NO PRELIMINARY CHECKING IS TO BE TAKEN FOR THE DESIGN CONCEPT OR THE GENERAL COMPLIANCE WITH THE FEDERAL CONTRACT DOCUMENTS. THE CONTRACTOR SHALL BE RESPONSIBLE FOR THE FABRICATION, INSTALLATION, AND MAINTENANCE OF ALL OTHER ITEMS AND THE SAFETY FACTOR PERFORMANCE CRITERIA.

<b>Renaud Bros. Inc.</b> 283 Fort Bridgeman Rd. #2 Vernon, VT. 05354 Phone 1-802 257-7383		Holes: 13/16 UNF
Bolts: 3/4" DIA M16-I GALV		Steel GR: M270-50 UNF
Paint: PER SPECS		Surface Prep: PER SPECS
Rev. No:	Date: 4-28-09	Job No.
Project: <b>WALLINGFORD BRIDGE</b> WALLINGFORD, VT		Sheet No. <b>E1</b>

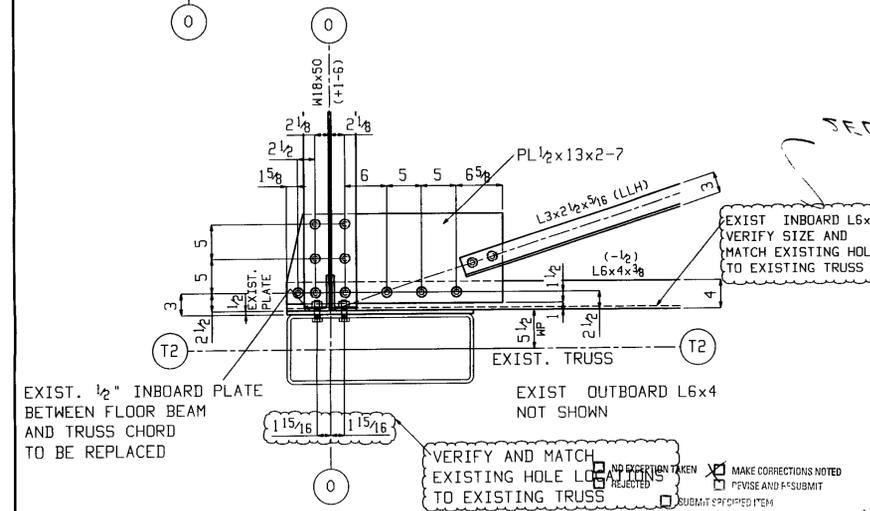
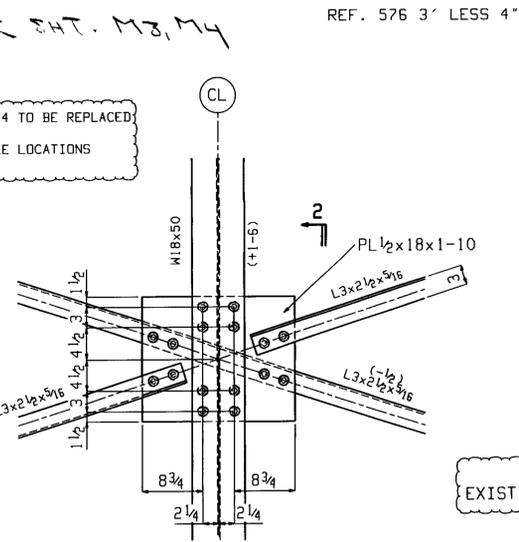
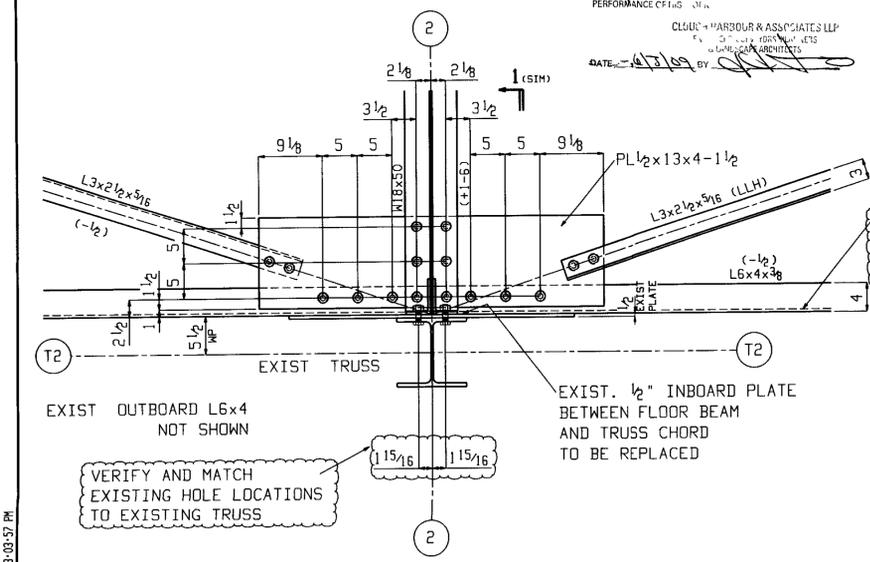
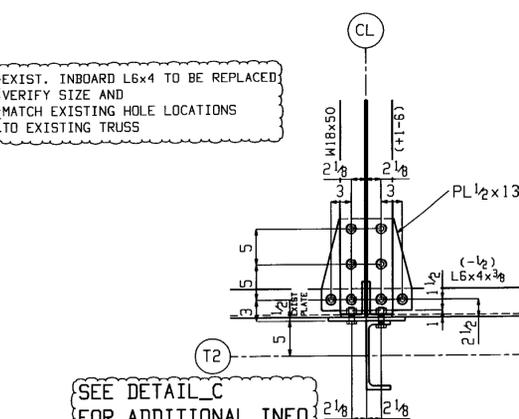
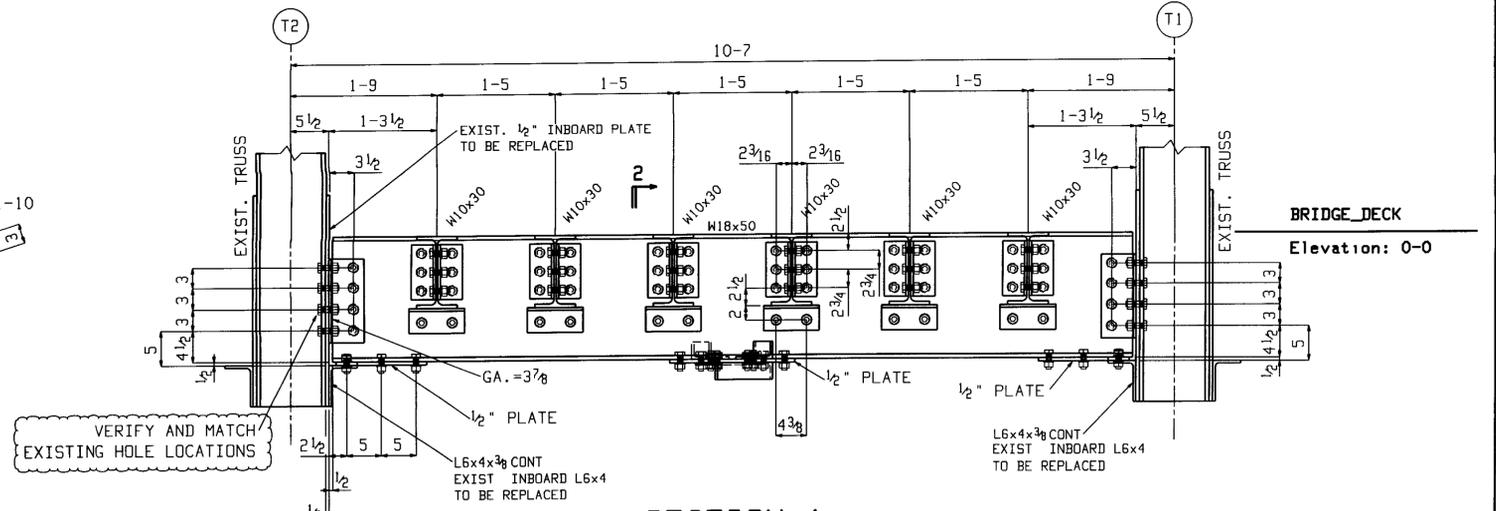
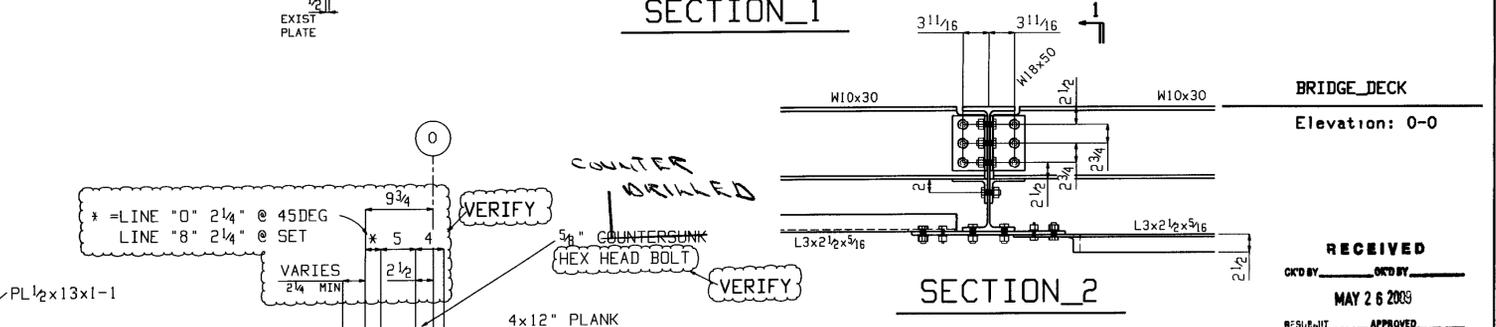
VERIFY AND MATCH EXISTING HOLE LOCATIONS

VERIFY AND MATCH EXISTING HOLE LOCATIONS TO EXISTING TRUSS

EXIST. INBOARD L6x4 TO BE REPLACED. VERIFY SIZE AND MATCH EXISTING HOLE LOCATIONS TO EXISTING TRUSS

VERIFY  
5/8" COUNTERSUNK HEX HEAD BOLT  
VERIFY
